ADDENDUM NO. 2

GS# 203-053 East Central Community College Band Hall Addition Decatur, MS.

EAST CENTRAL COMMUNITY COLLEGE
NEW BAND HALL
DECATUR, MISSISSIPPI

GS # 203-056
 EAST CENTRAL
 COMMUNITY COLLEGE
 BAND HALL ADDITION
 DECATUR, MS.

PROJECT NO. 16-478	SHEET NO. FP-1.1R1
DRAWN LPW	CHECK DLG

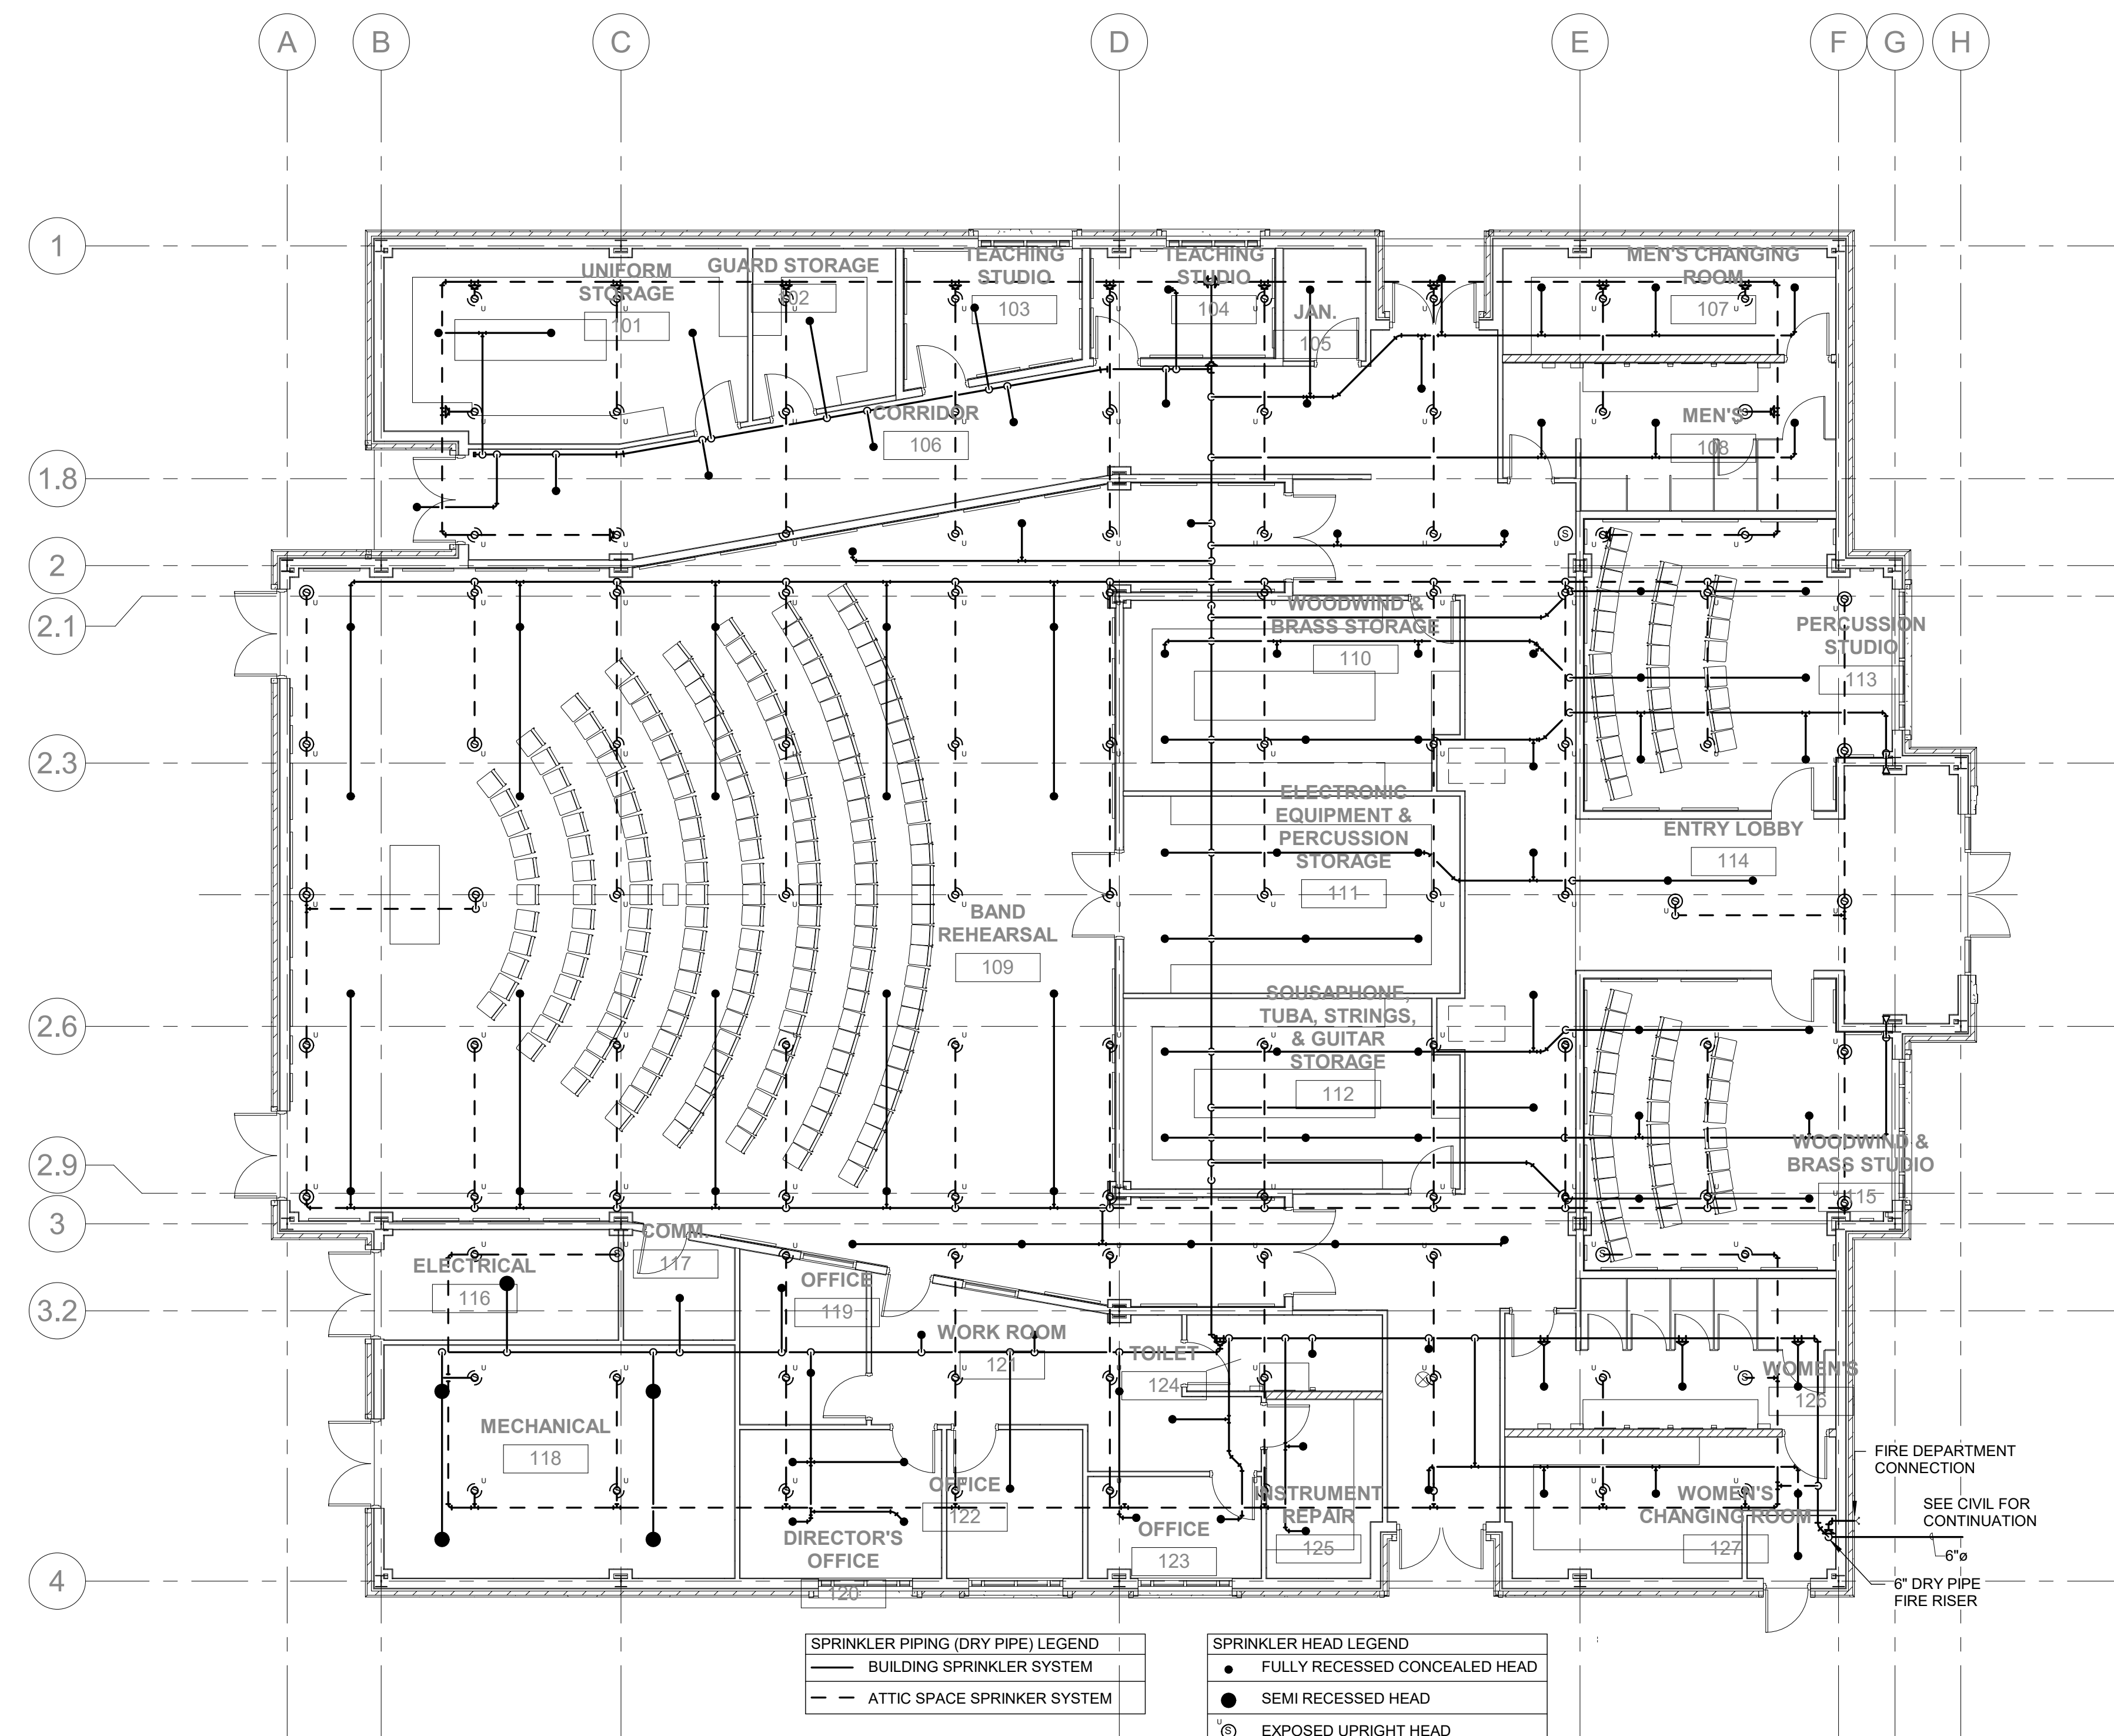
Item No. 2: Drawings, Sheet FP1.1, Floor Plan-Fire Protection: Delete Sheet FP1.1 entirely and replace with revised Sheet FP1.1R1. Revisions include adding dry pipe sprinkler system in attic space.
